TWT ST LEONARDS 23-35 ATCHISON STREET, ST LEONARDS

APRIL 2017

This report has been prepared to address the urban design issues in comments made by North Sydney Council (NSC) in a letter dated 5 April (*CONCEPT FOR 25-35 ATCHISON STREET, ST LEONARDS*) in response to the submission of a preliminary concept proposal on 14 March 2017.

Fig. 1.01 Indicative Floor Plans of 21 Atchison Street

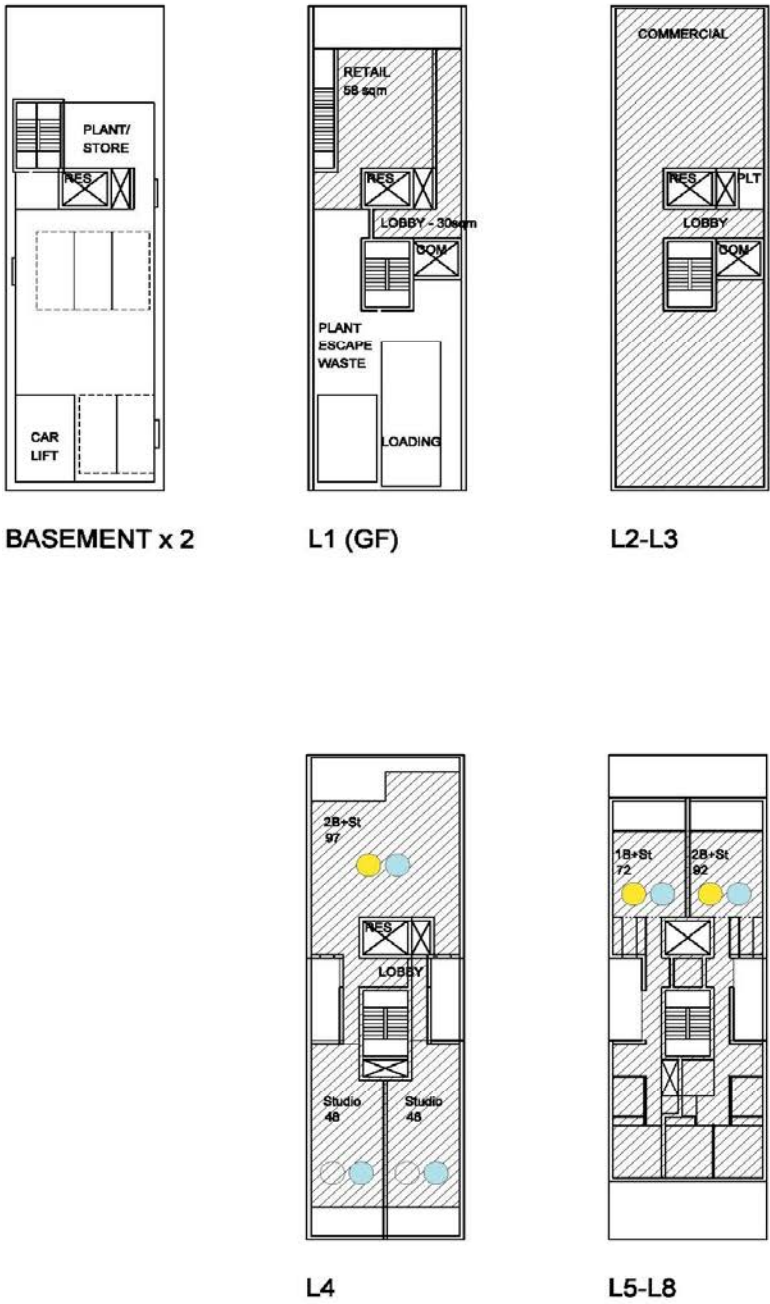
NSC: “Alternatively, if negotiations are unsuccessful, the concept proposal for 23-35 Atchison Street is revised to have full regard to the principles and separation requirements of the ADG assuming the future development 21 Atchison Street with nil side setbacks.”

Design testing was undertaken for 21 Atchison Street. The site is approximately 35.07m deep by 10.17m wide. To the west the Nexus building has a zero setback to 8 storeys with light well that is approximately 6m x 3m in dimension. The tested design utilises floorplates that would be generally applicable under both North Sydney DCP 2013 (DCP 13) and the controls proposed by the St Leonards / Crows Nest Planning Study - Precincts 2 and 3 Precinct (Planning Study).

The proposal is for an 8 storey building with zero setbacks and two light wells that are approximately 6m x 2.5m in dimension with a 4 storey podium street frontage. Due to the Nexus building form it is not possible to construct 21 Atchison Street above 8 storeys. Commercial space is proposed to the first 3 levels and can deliver approximately 1.69:1 FSR. Refer Appendix for Yields Table of 21 Atchison Street.

SEPP 65 and ADG compliance is achievable to both 21 Atchison Street and 23-35 Atchison Street.

Fig. 2.03 23-35 Atchison Street

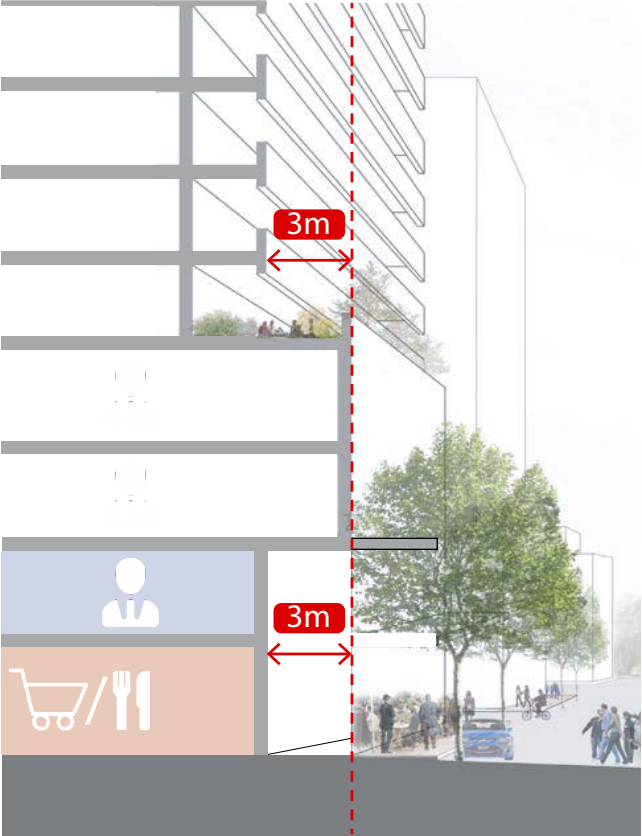
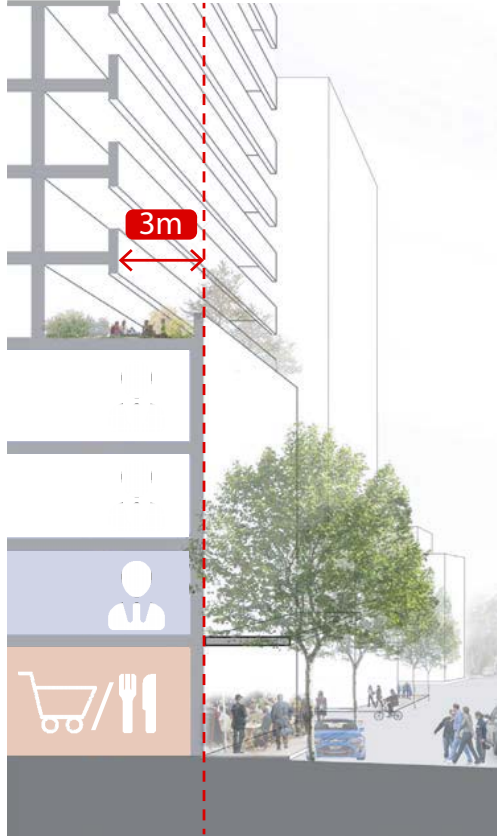
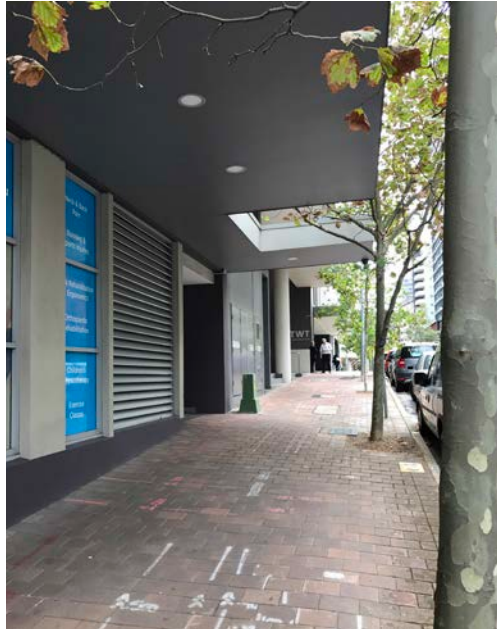
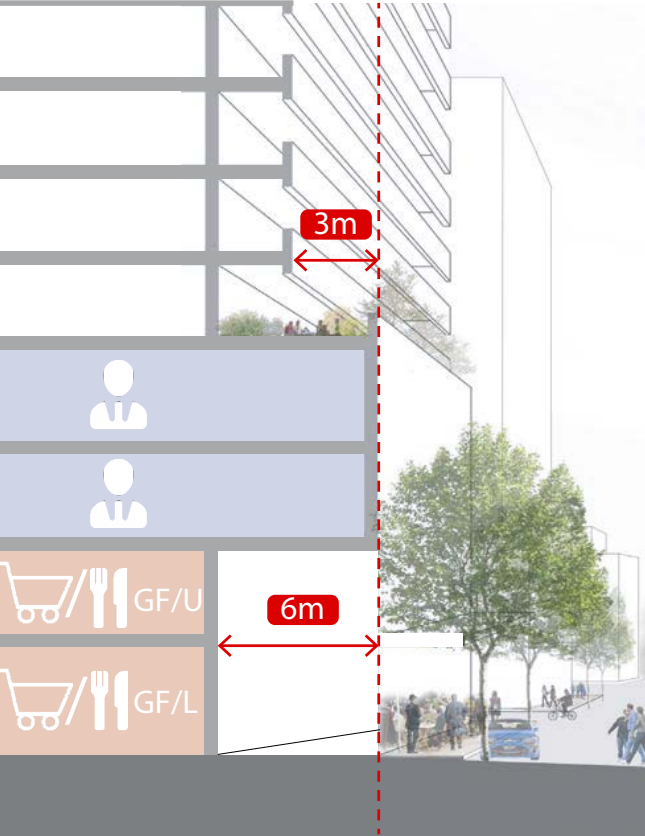
NSC : “The proposal is to be amended to incorporate a 3m whole of building setback.”

The concept proposal seeks to achieve the objective of the 3m setback to create a sense of space and openness at the at the transition point from the high density residential to the dedicated mixed use development leading up into the core of St Leonards without providing a 3m whole of building setback.

The reason for this is that there are 3 recent apartment buildings completed in Atchison Street all of which are not set back 3m at podium level.

Of these T1 contributes most positively with a 3m ground level setback that is 2 storeys high and 3m deep and relatively flush with the footpath level. Refer diagrams Fig. 2.01-03.

The proposal seeks to maintain continuity in the existing recently completed streetscape in terms of both the alignments of podiums and towers whilst achieving the public domain objectives. The proposal has Ground Level Upper and Ground Level Lower setback at 6m.

Fig. 2.05 Proposed Public Domain Diagram

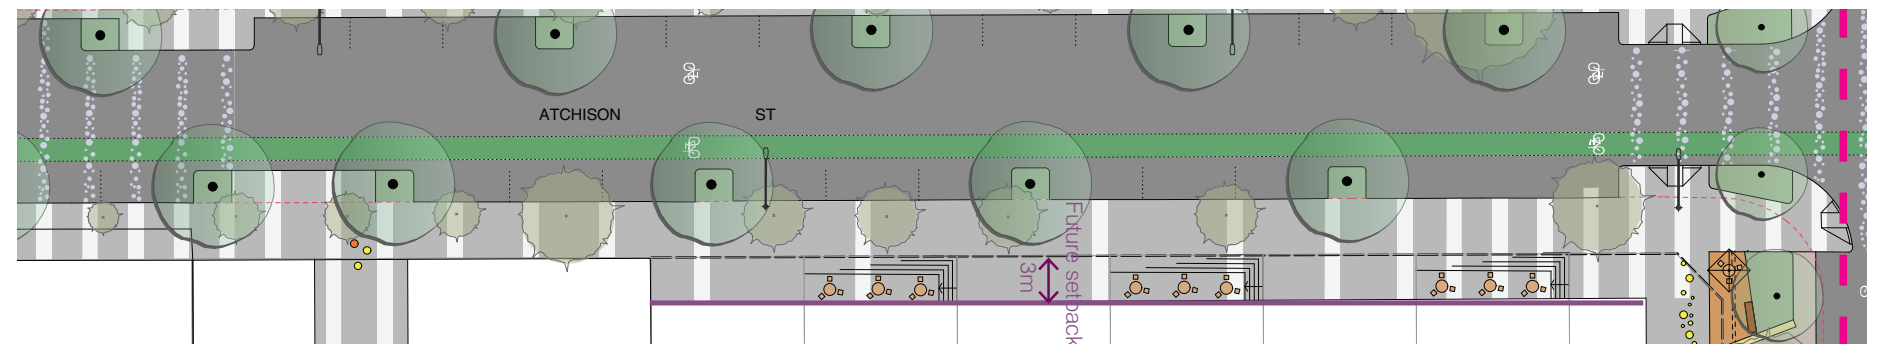
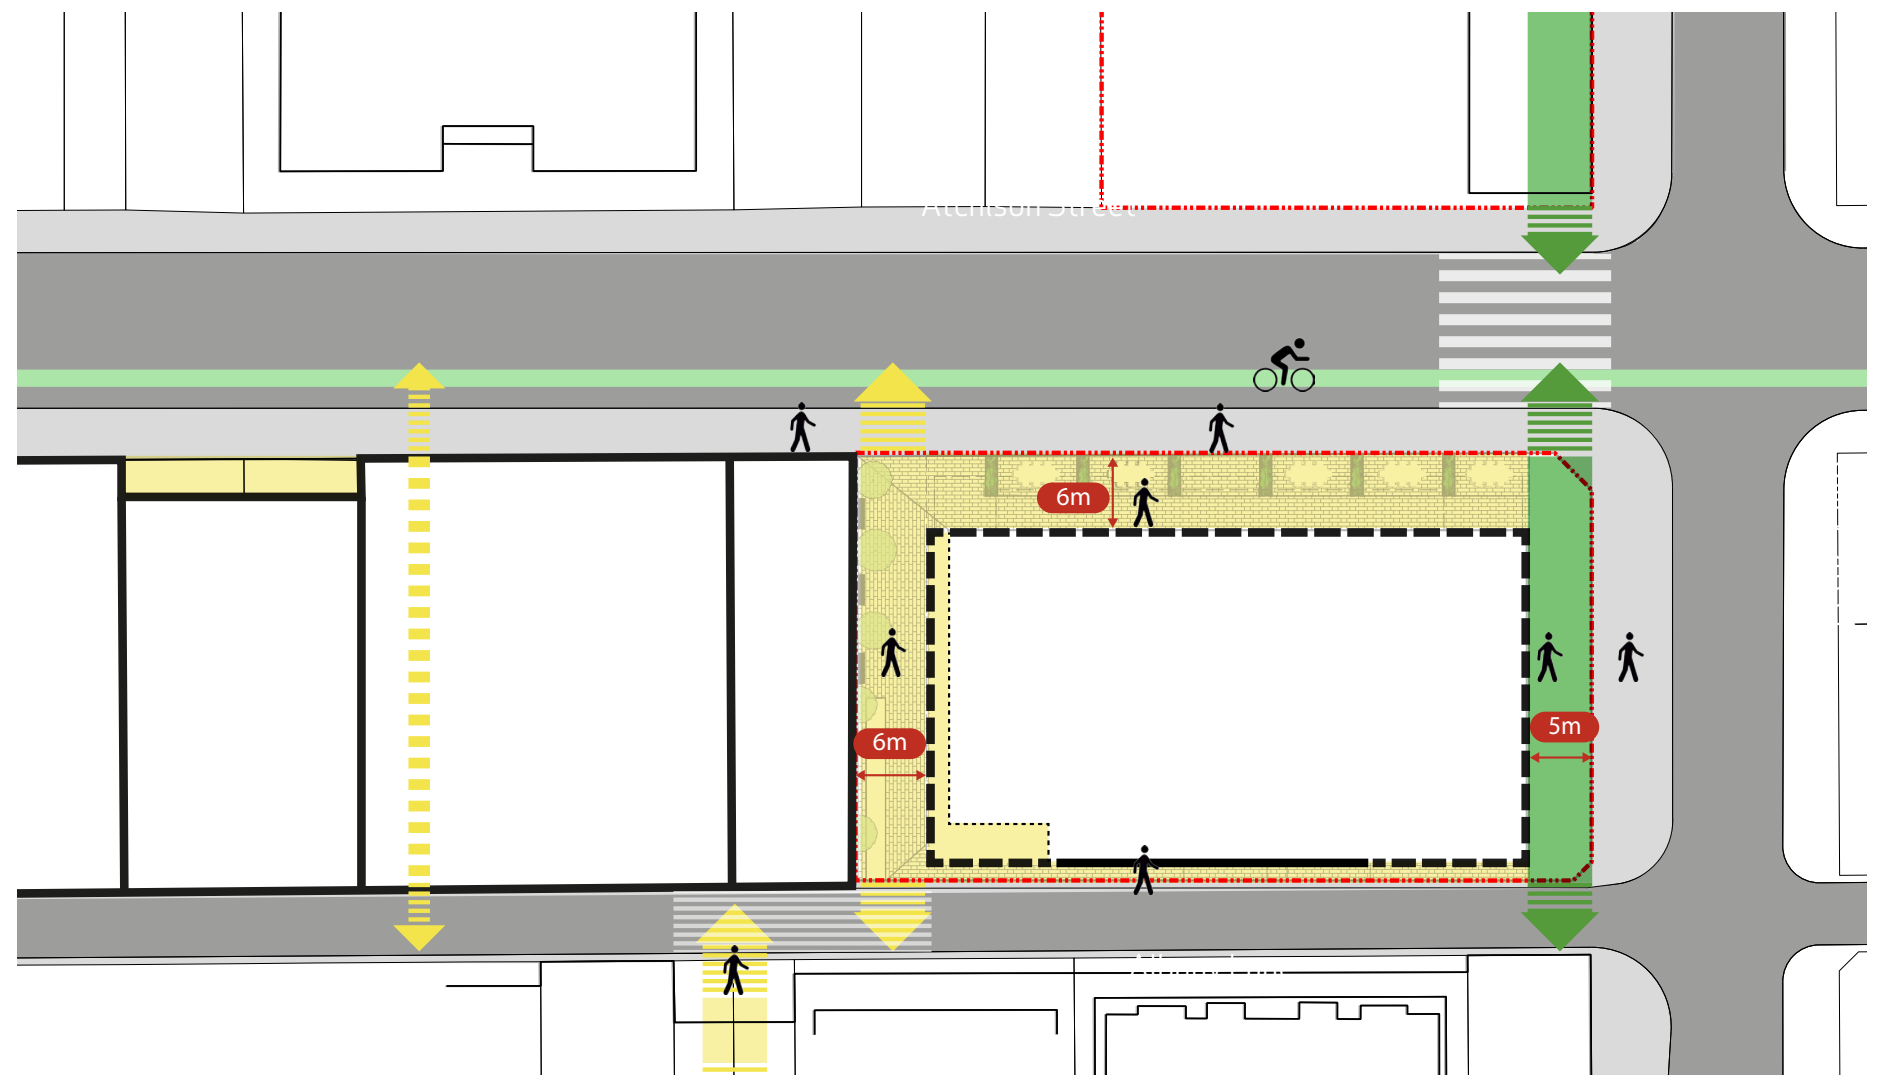
NSC: "The revised proposal should have regard to the streetscape upgrade plans for Atchison Street in the Draft Public Domain Upgrade Report – St Leonards."

The public domain objectives will be achieved by the following design actions

1. Provision of a podium form that relates to the scale and alignment of existing podiums on the south side of Atchison Street.
2. Both the Ground Floor Lower and Ground Floor Upper commercial spaces are to be set back a minimum 6m from the boundary.

3. Level 1 and level 2 floor plates are only able to project to the boundary for a maximum 60% of the street frontage. This is designed to enable visually dynamic external public space, increase the sense of openness at street level and to increase solar access to outdoor seating areas.

4. Level 1 and 2 floor plates are to project to the podium street alignment to the extent necessary to create the feeling of a podium street wall.
5. (Refer NSC Point 6) The provision of an open to air through site link enables the TWT Site 1 to contribute to the sense of openness whilst maintaining existing street alignments and establishing a clearly discernible street form.

Fig. 3.01 Building Envelope Section / Atchison Street Elevation

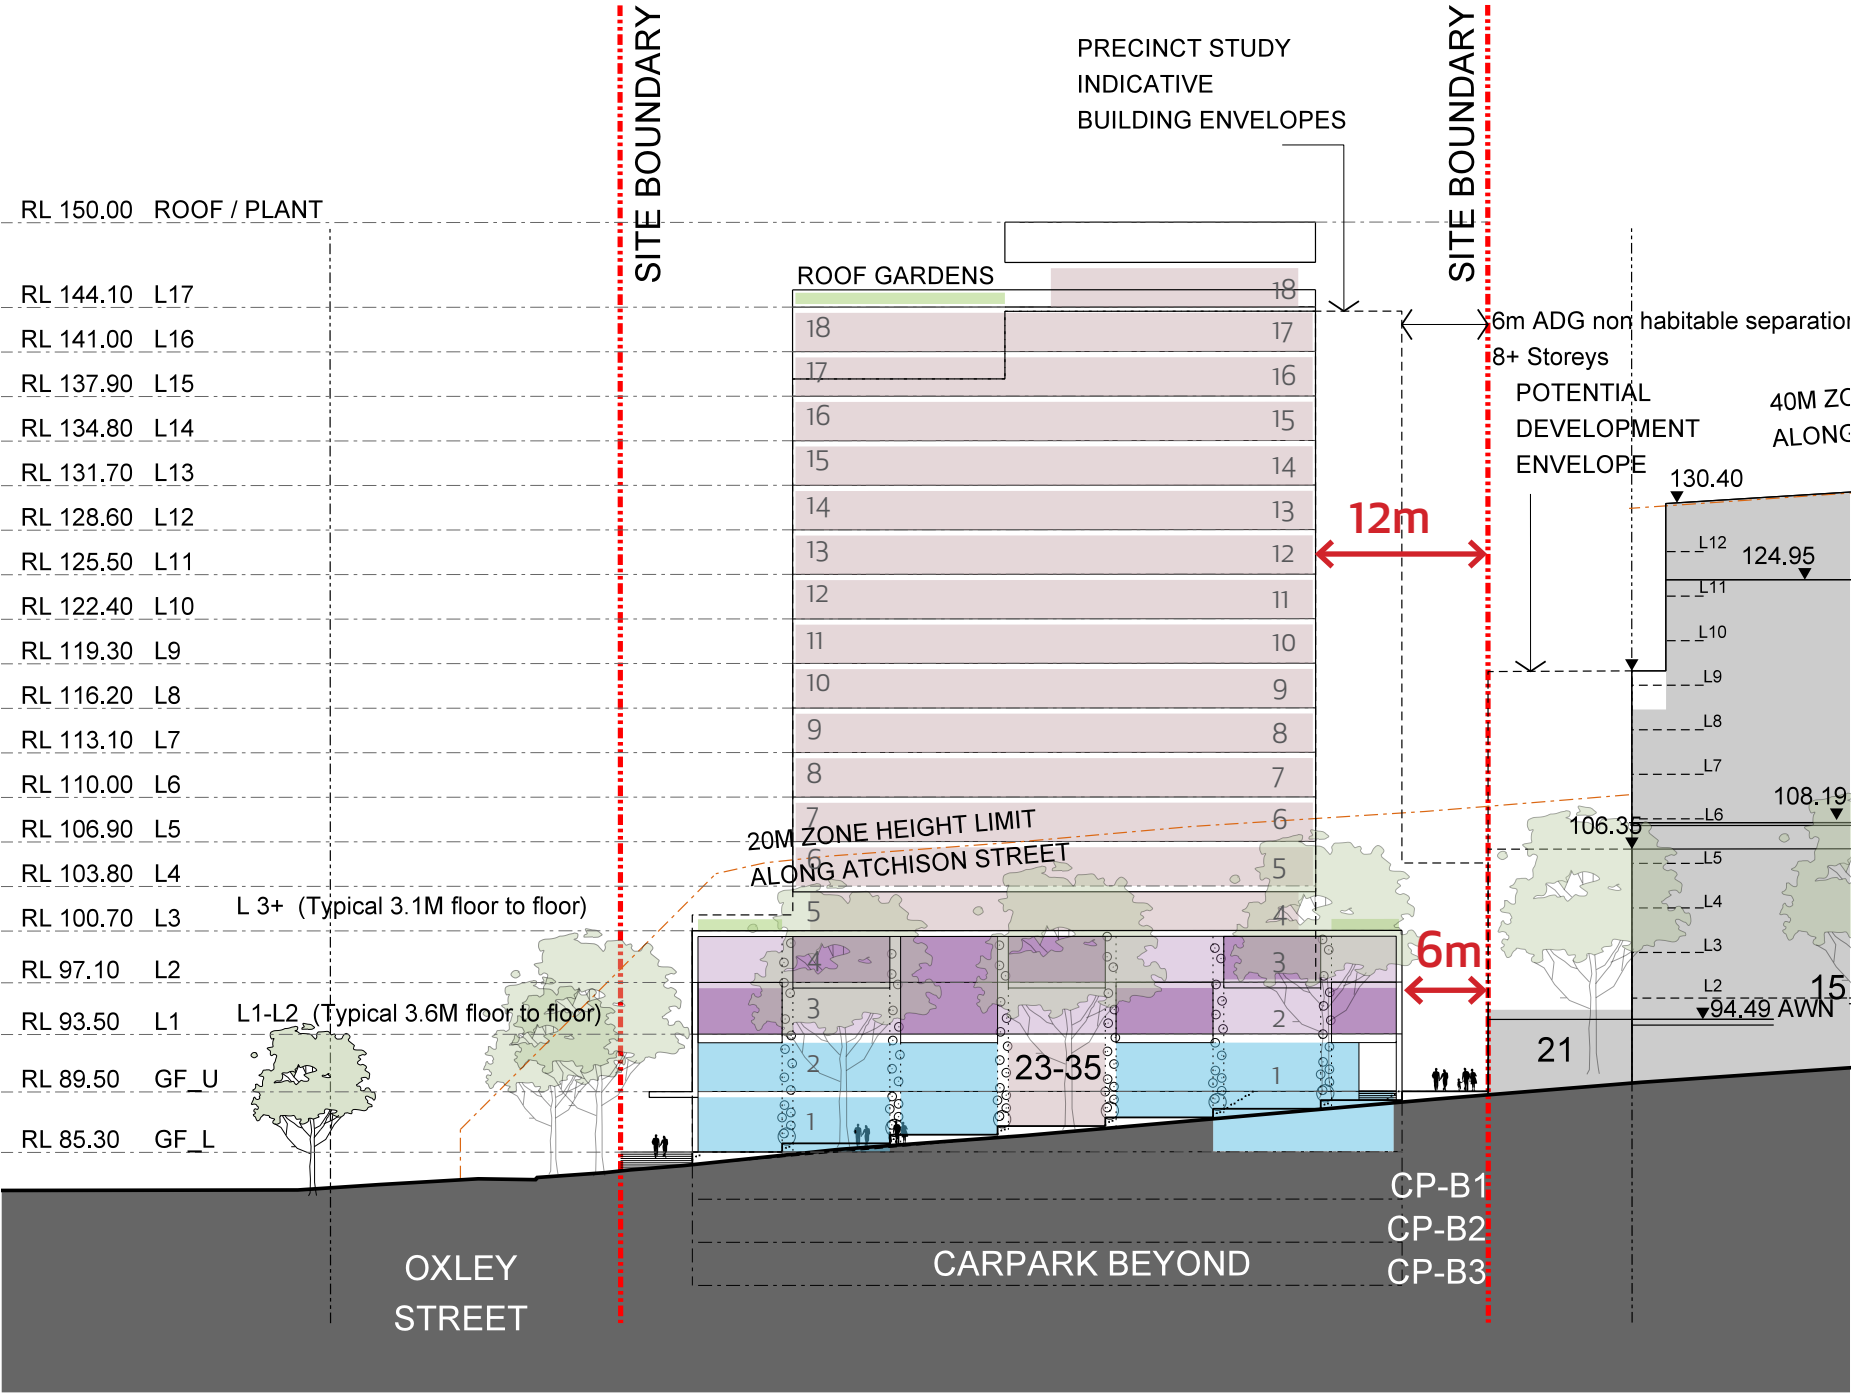
NSC : “The proposal is revised to reflect a tower apartment (podium) typology without the 8 storey “bridge connector” to the west”

NSC : “The proposal demonstrates how ADG separation distances for the resultant above podium tower form have been applied to the west”

The concept proposal been modified to provide a distinct tower element with a 12m setback to the western boundary with No. 21 as required by ADG 2F and 3F-1. Refer Fig. 3.01 and Fig. 4.01-4.03.

Fig. 4.01 Indicative Floor Plan Layout Of The Tower

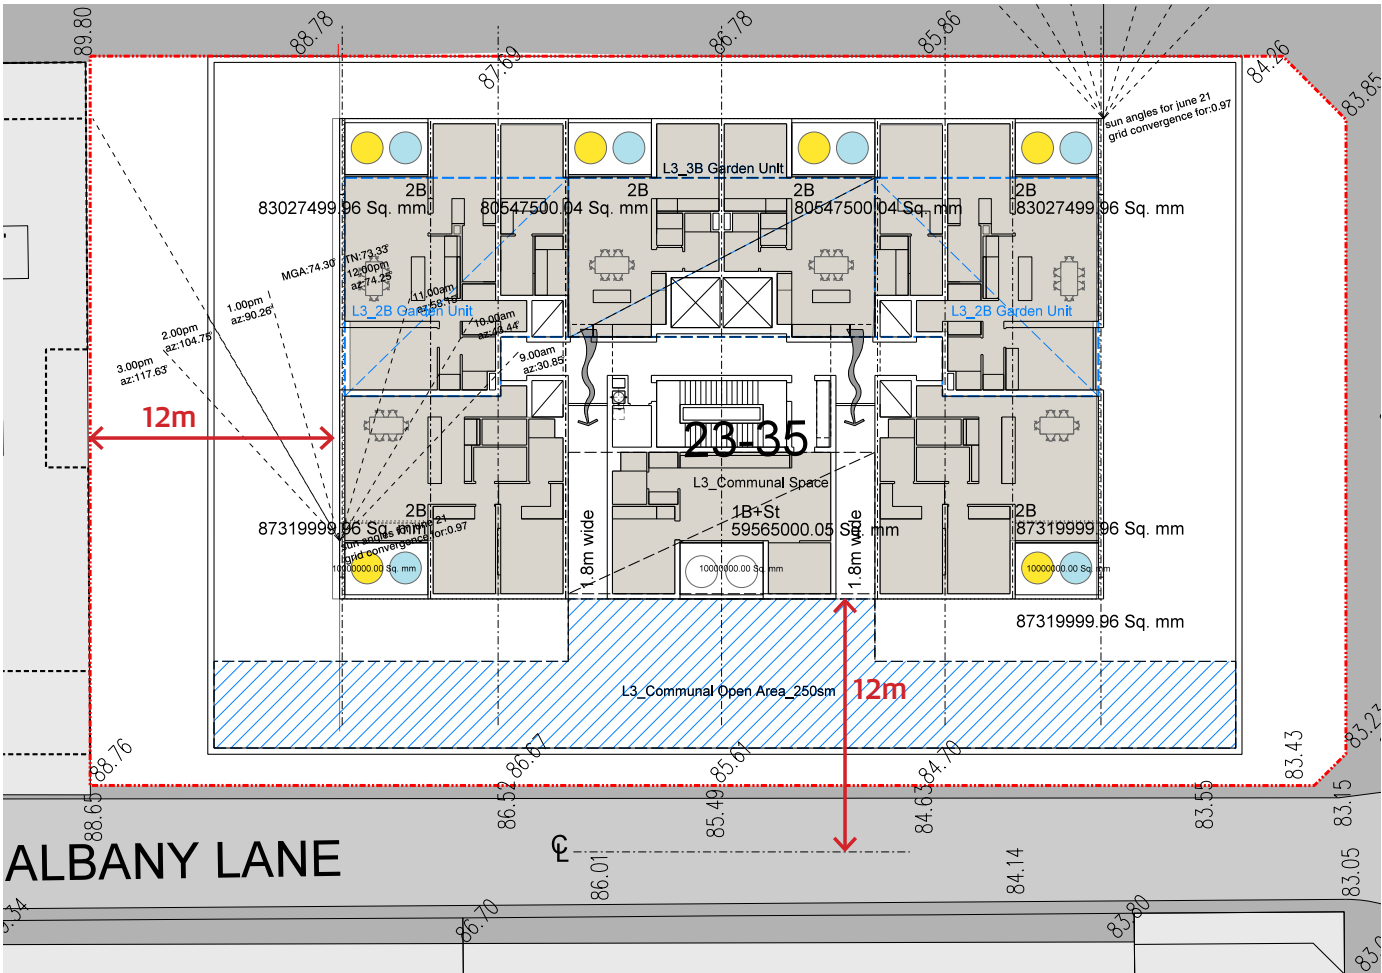
NSC : “The proposal is revised reduce the tower depth to a maximum of 18 metres and/or show how articulation of the tower form will achieve an appropriate level of internal amenity and address SEPP 65 design considerations to the southern properties and amend the FSR estimate accordingly”

NSC : “Please submit an indicative floor plan layout for the tower.”

The tower depth has been reduced from 24m to 23.1m. Since the tower length is approximately 36.6m and all four facades are available for habitable spaces the floor plans are capable of delivering excellent amenity.

The indicative plan shown here is capable of delivering all key SEPP 65 Part 4 - Amenity criteria.

The SEPP 65 separation to the Albany Lane properties has increased from 18m to 19m. These buildings are generally 6 storeys high. A 19m separation is in excess of minimum separations for buildings up to 8 storeys in the ADG and satisfy the following relevant ADG Objectives;
